PLANNING COMMISSION MEETING

Project Name: 9101 Highland
 Description: Preliminary site plan approval recommendation & special land use approval
 Date on Agenda this packet pertains to: December 5, 2024

RE: 9101 Highland Road-Proposed Commercial Development- Preliminary Site Plan Review – 2nd Review

**Preliminary Site Plan / Special Land Use Review
for
White Lake Charter Township, Michigan**

TITLE:
COVER SHEET

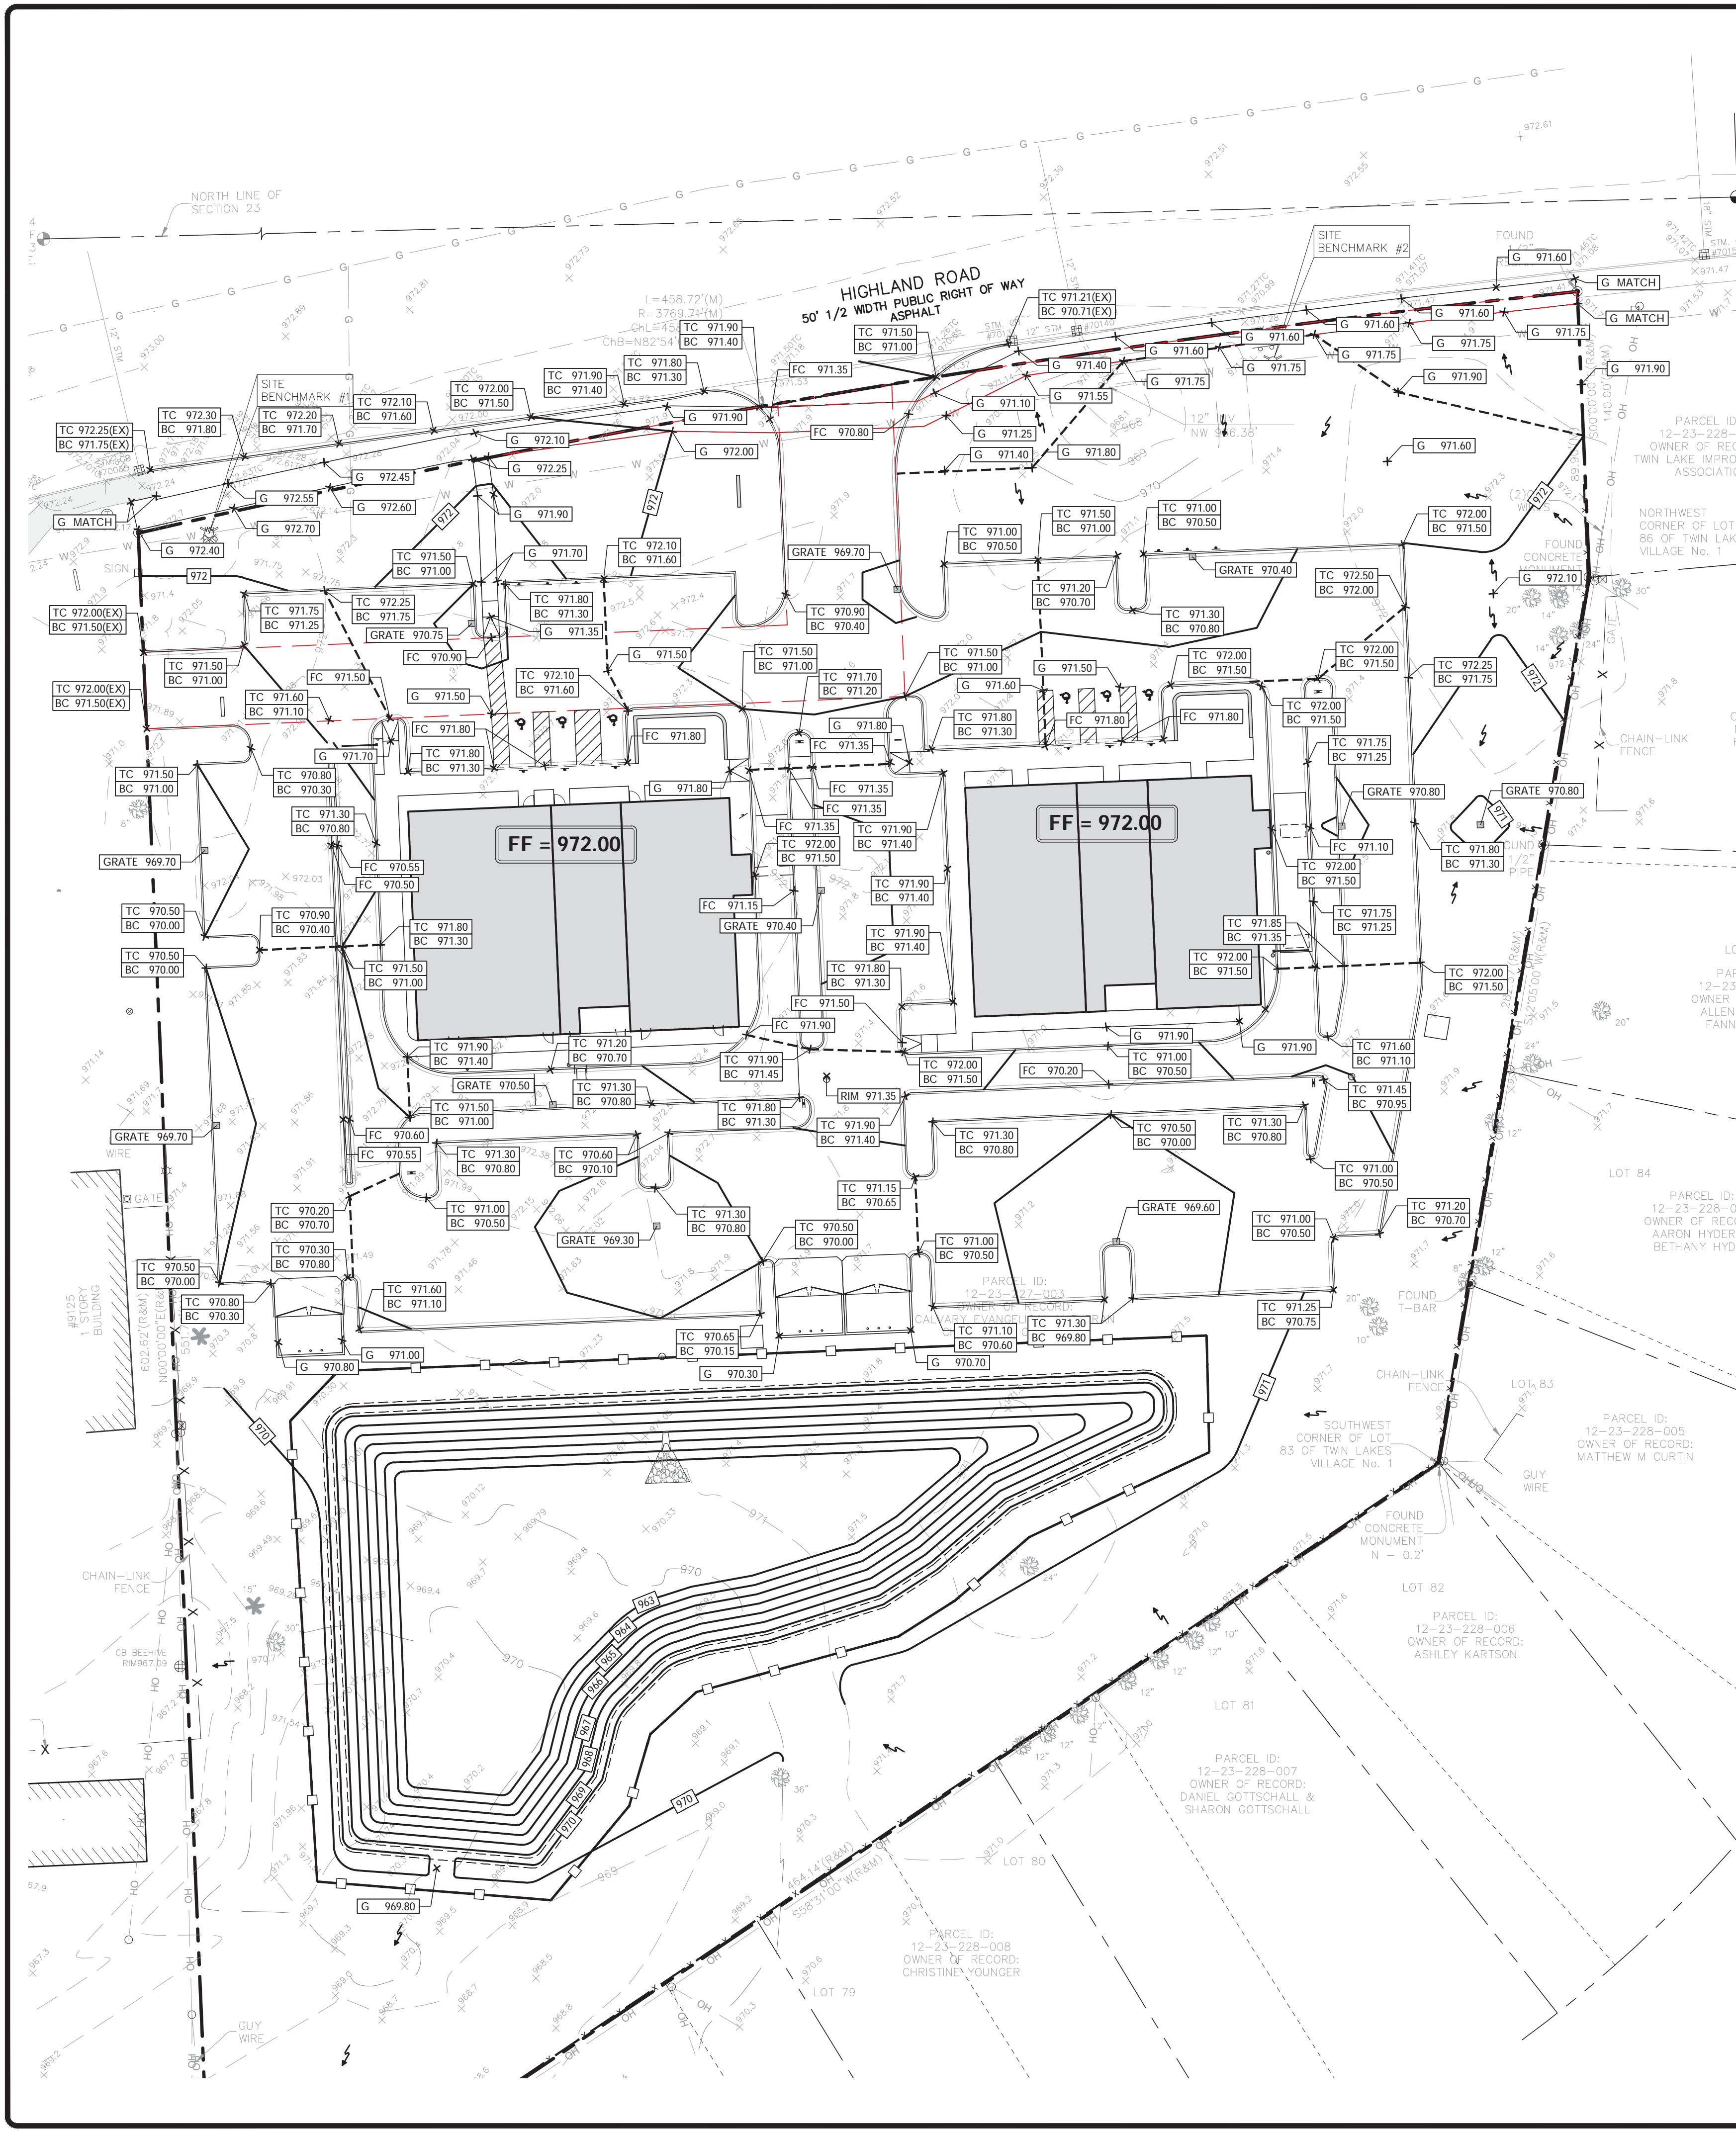
- a) *Cover sheet C-1- Provide ALTA/NSPS Land Title Survey with next submittal. Comment addressed at the preliminary level and remains. The survey has now been provided. Please provide surveyor seal and signature on this sheet on the Final Site Plan/Final Engineering Plan.*

TITLE: **GRADING PLAN**

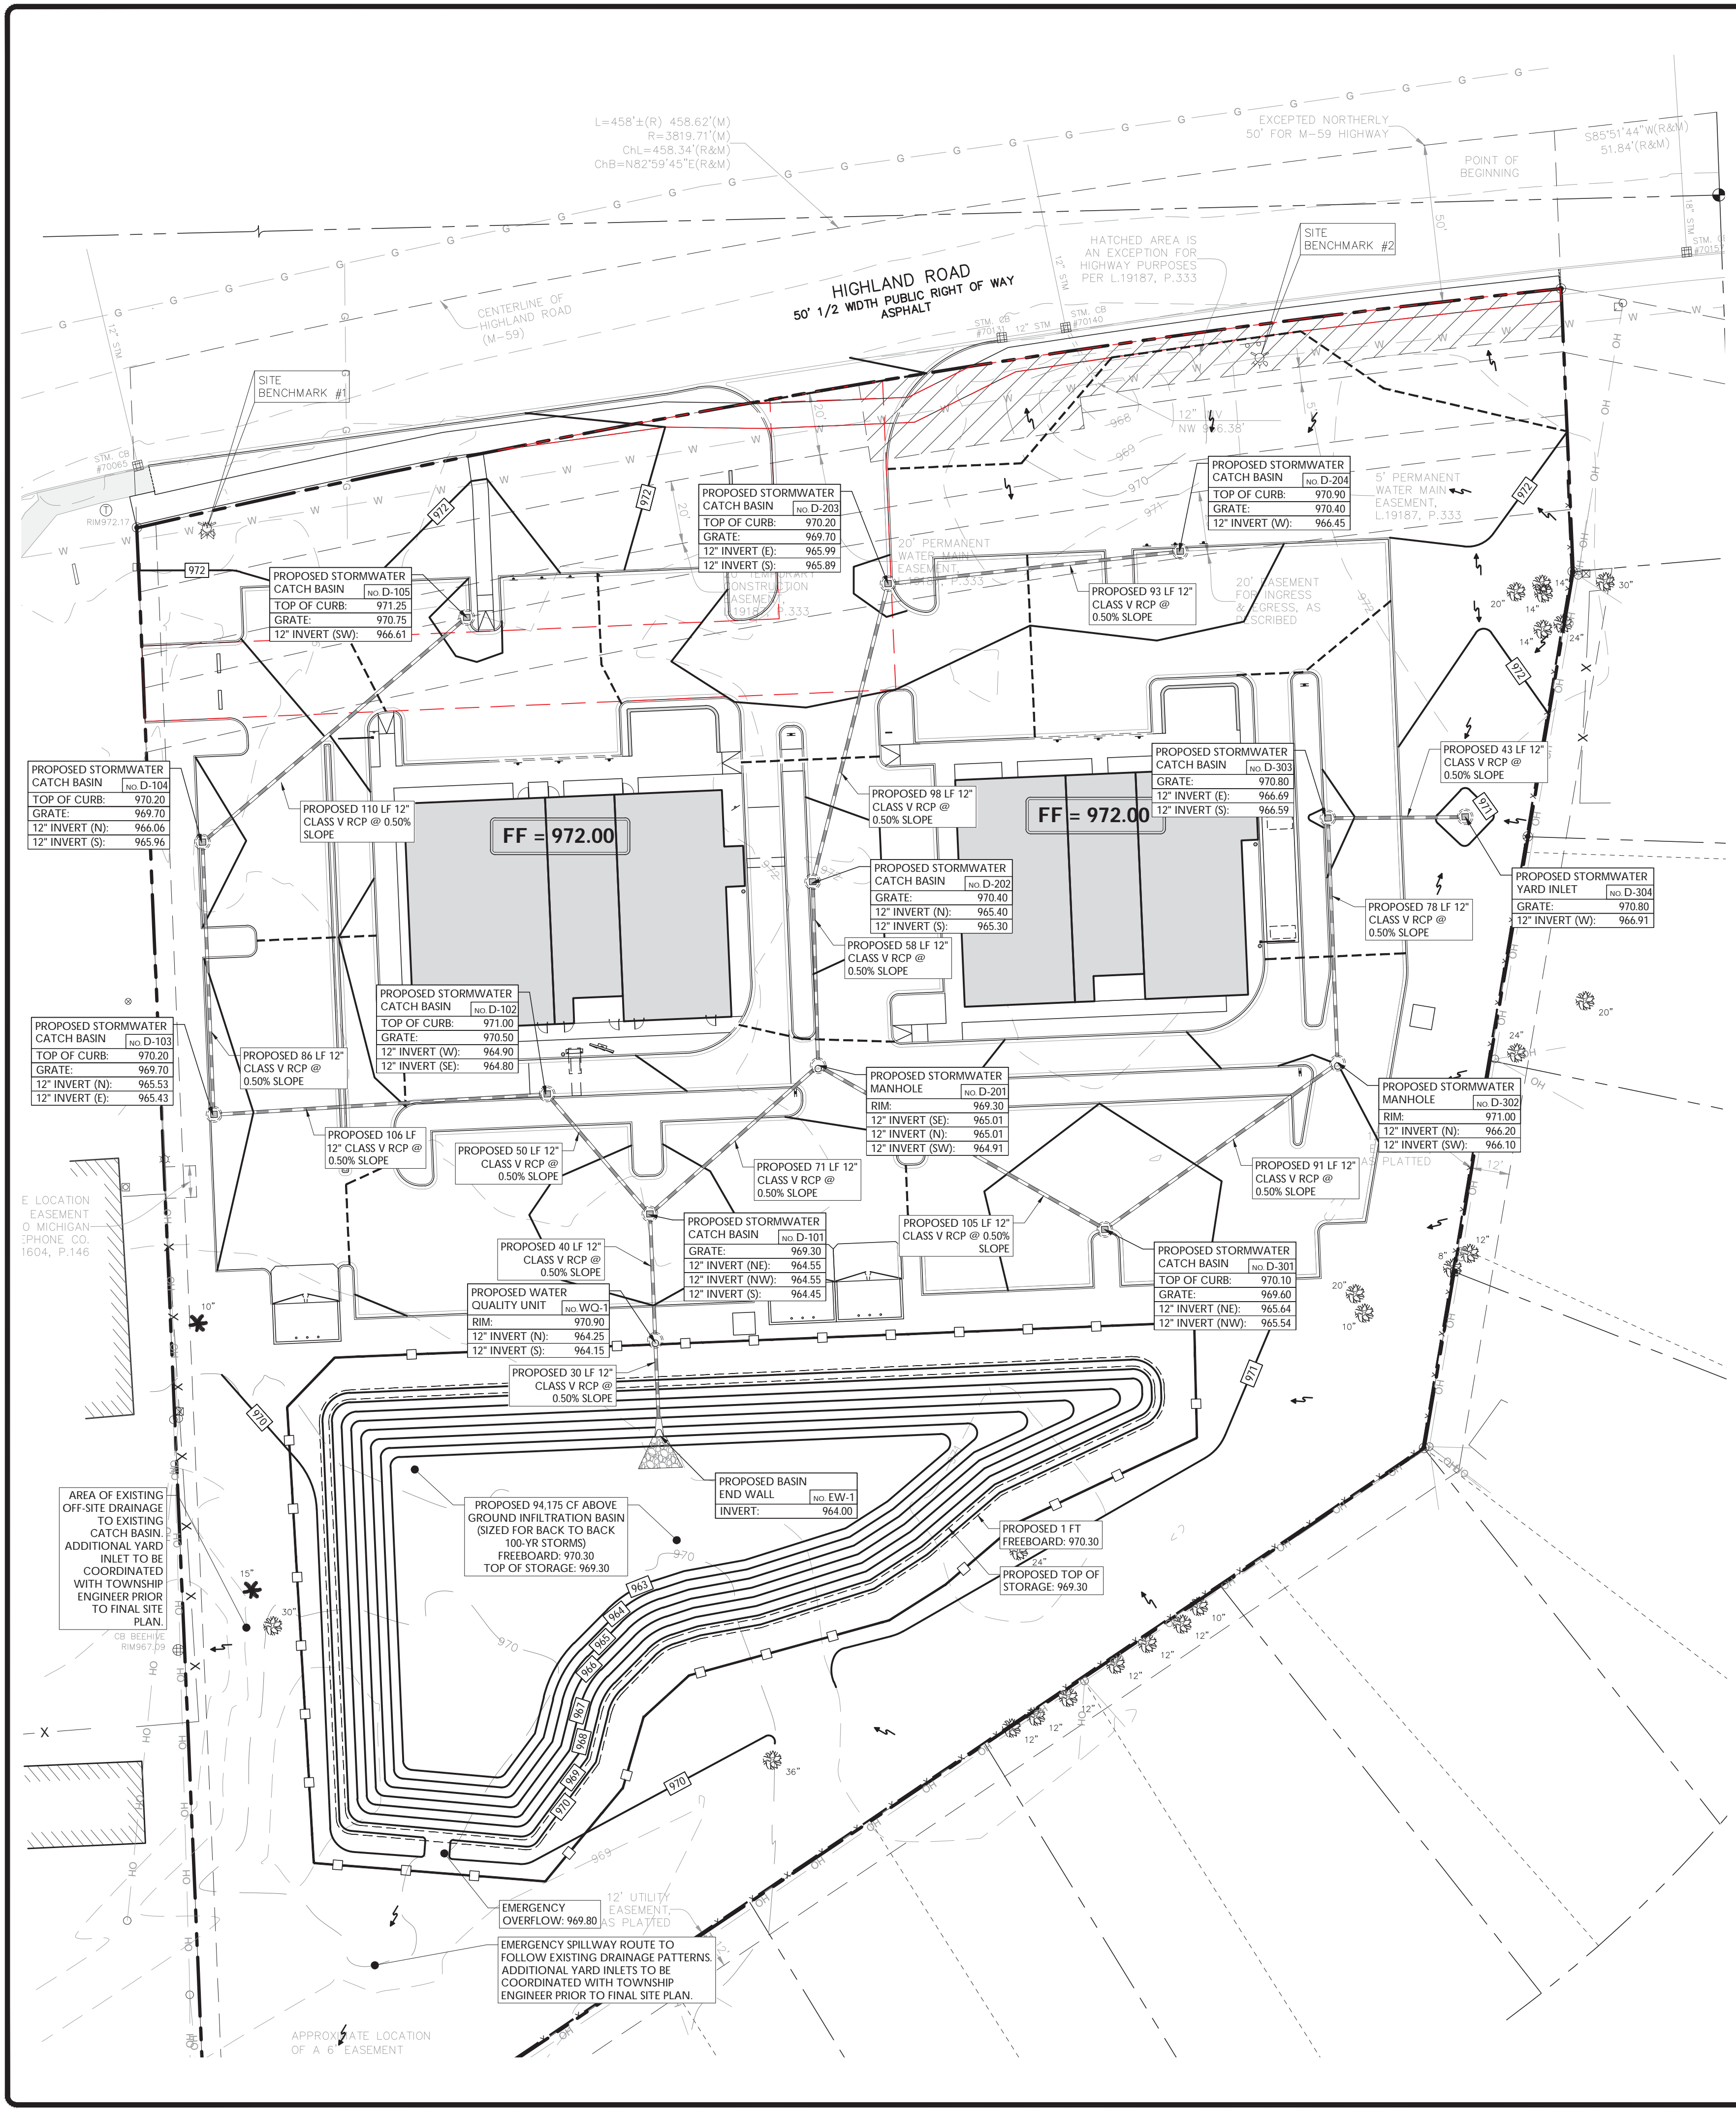
- k) *Sheet C-4- What is the grading intent for the northeastern greenspace area of the site? We note that there is an existing storm sewer end section which connects to the existing 12" diameter storm sewer that crosses M-59. It is assumed that this end section is to collect the drainage at the low point of approximately 966' and route the drainage to the north under M-59; however, the existing CB to the*

north (#70140) shows a higher invert elevation than the existing ES elevation to the south. Please clarify. We also note that the site post- development runoff to this end section shall be $<$ or $=$ to the current runoff (Q) to this area. **Comment addressed at preliminary level and remains. The existing pipe shall be removed, and the area regraded such that the depression shall be filled. Per the design engineer, calculations are intended to be provided on the FSP/FEP to demonstrate post development runoff to the M-59 right of way be $<$ or $=$ to the current runoff.**

- l) Sheet C-4- Grading Notes- Note 5-Minimum slope for concrete surfaces can be 0.50% as per WLT Engineering Standards. **Comment addressed. Note has been updated.**

- m) Preliminary grading of the site has been proposed and demonstrates general drainage patterns mainly within the confines of the proposed impervious areas; please provide on the revised preliminary site plan general proposed grading for all greenspace areas. A more detailed grading review will be provided at the time of Final Engineering Plan submittal/review. **Comment remains.**

TITLE: UTILITY PLAN

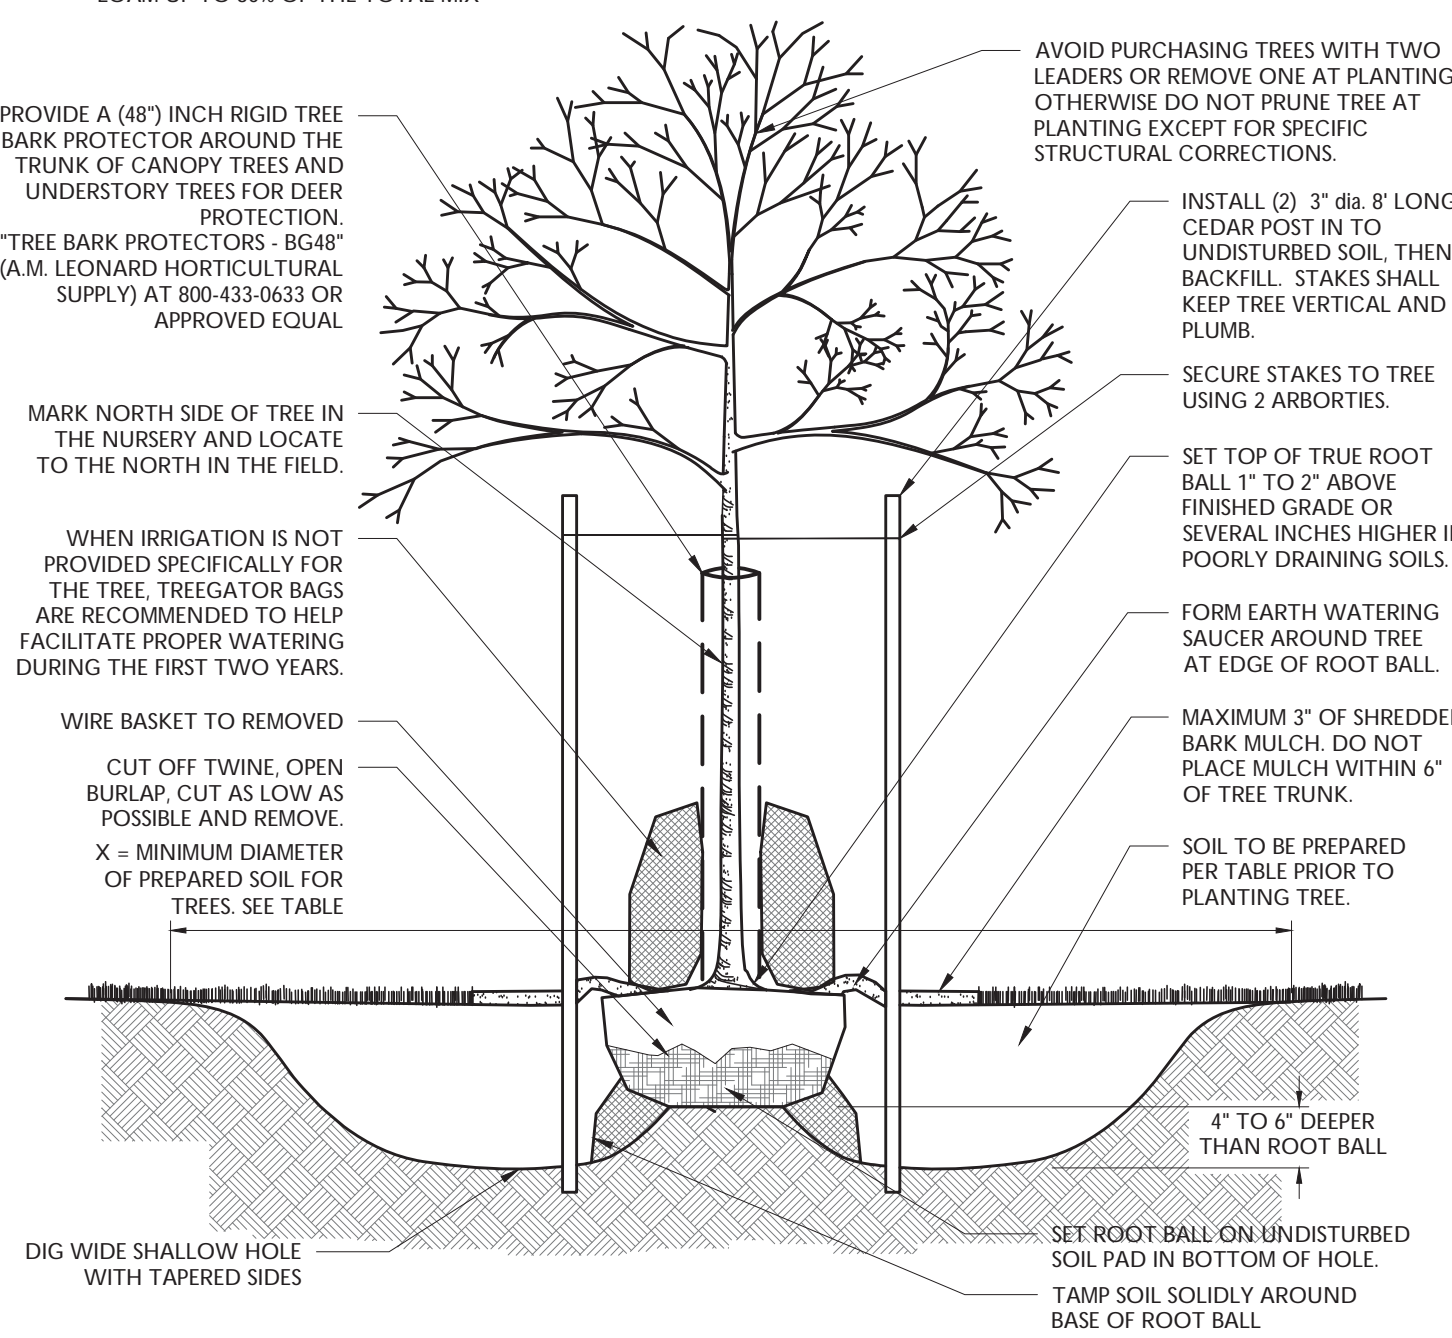
- v) *Sheet C-6- Specify size of the proposed grease interceptor for the westernmost building. A minimum capacity of 1000 gallons is required. **Comment outstanding. Although a detail for the GB-75 grease trap has now been provided on plan, it appears that the capacities (liquid-125 gal, grease-118 gal, and solids-31 gal) fall significantly short of the 1000 gallon minimum volume requirement.***

- w) *Sheet C-6-Since the sanitary sewer leads are each contributing to a sanitary sewer grinder station, all leads shall be 6" diameter and shall have cleanouts at 75' intervals and at each change in direction. The gravity lead from the monitoring manhole to the grinder station shall also be 6" diameter. **Comment addressed. All leads are now 6" diameter and clean outs are shown every 75' and at directional changes in leads.***

- x) *Sheet C-6- Move duplex grinder pump outside of the existing watermain easement. **Comment addressed. Pump has been moved outside of existing watermain easement.***

- y) *We defer to the Township Fire Department regarding hydrant coverage. **Comment remains as a notation.***
- z) *Sheet C-6- Shift the westernmost water service line west away from influence of monument sign. **Comment addressed. Water service line horizontal separation between it and sign has now been optimized.***
